RH  PETERSON co.
Technical Services Bulletin 17-02

Fire Magic® and AOG Grill Enclosure Construction Update

Fire Magic and AOG installation manuals are being updated to clarify the ANSI Z21.58/CSA 1.6-2015 ventilation and other requirements for field constructed grill enclosures/islands. The attached pages 8 and 9 from the Fire Magic manual highlight the areas that are being modified.

Fig. 8-1 Ventilation detail

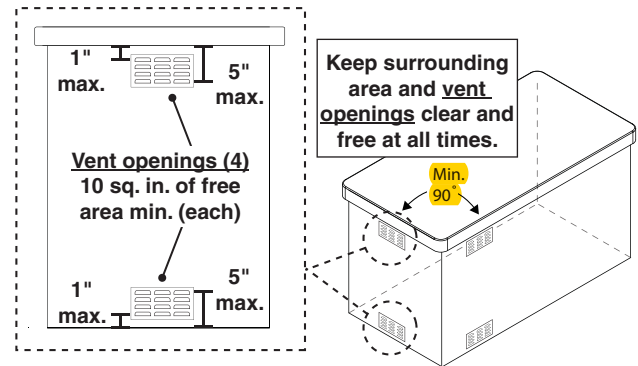
One side of the enclosure shall be left completely open to the outside; OR 4 (minimum) ventilation openings **MUST** be created (reference Fig. 8-1 and Fig. 8-2):

- Each opening must have a minimum of **10 sq. in.** of free area. The openings must be equally sized.
- Two openings must be in the side walls of the enclosure, at the top level, and spaced at a minimum of 90 degrees. The openings must begin 1" or less below the countertop level and end no more than 5" below the countertop level.
- Two openings must be in the side walls of the enclosure, at the floor level, and spaced at a minimum of 90 degrees. The openings must begin 1" or less above the floor level and end no more than 5" above the floor level.

- Minimum 4 openings
(2 per side wall - spaced at minimum **90 degrees**)
- Top openings: within 5" of countertop (see below)
- Bottom openings: within 5" of floor (see below)
- Each vent opening: min. 10 sq. in. of free area

Fig. 8-2 Vent openings clearance

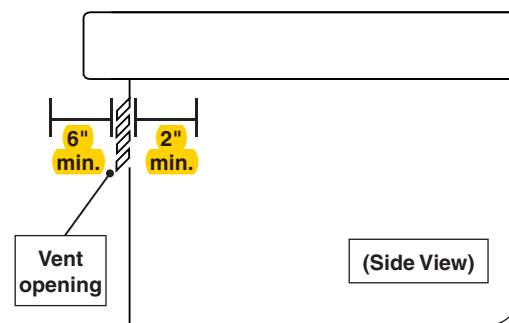
The clearance between the openings and any items outside of the enclosure is a minimum of 6". The clearance between the openings and any items within the enclosure is a minimum of 2". See Fig. 8-2.

- **6" min. clearance between all vent openings and any items outside of enclosure**
- **2" min. clearance between all vent openings and any items within enclosure**

Fig. 9-1 L.P. cylinder orientation

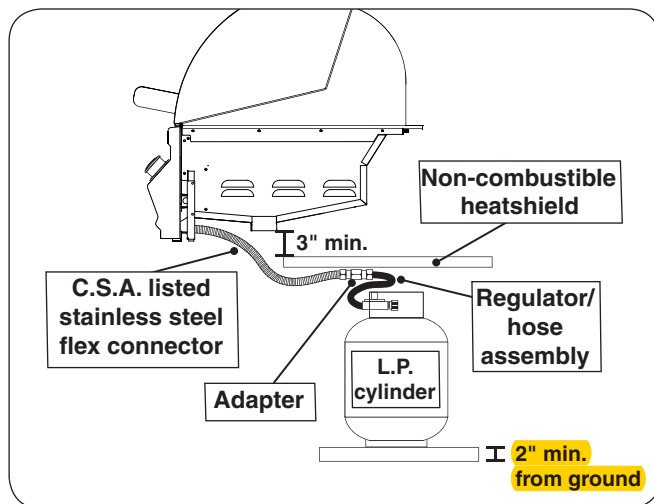
When a propane (L.P.) cylinder is installed inside of the enclosure, the guidelines below **MUST** be followed. FAILURE TO DO SO MAY CAUSE DAMAGE TO YOUR UNIT AND/OR PERSONAL INJURY. Reference Fig. 9-1 and 9-2 for an example.

- Only a C.S.A. listed stainless steel connector can be connected to the grill.
- The regulator/hose assembly coming from the cylinder can only be connected to the above mentioned grill flex connector. **DO NOT connect the regulator/hose assembly directly to the grill.** An adapter will be required.
- A non-combustible heatshield must be installed to protect the regulator/hose assembly and cylinder valve.
- The cylinder must rest at least 2" above the ground.
- An additional vent opening is recommended in the access door near the cylinder and at the gas connection level (minimum 10 sq. in. of free area).

Fig. 9-3 Optional RHP door w/ tank tray & louvers

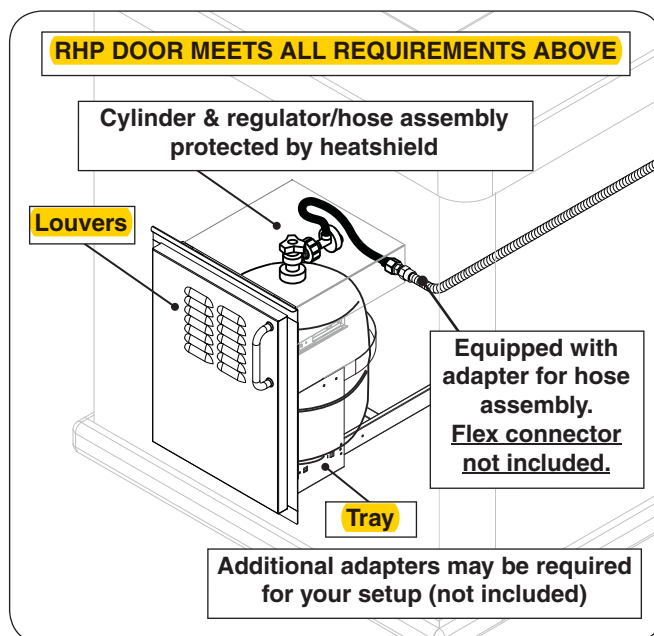
RHP offers an "access door with tank tray and louvers" which includes a heatshield that rests directly above the L.P. cylinder, a tray, and louvers to meet the cylinder install requirements. The door is shown in Fig. 9-3. Contact your dealer for ordering information.
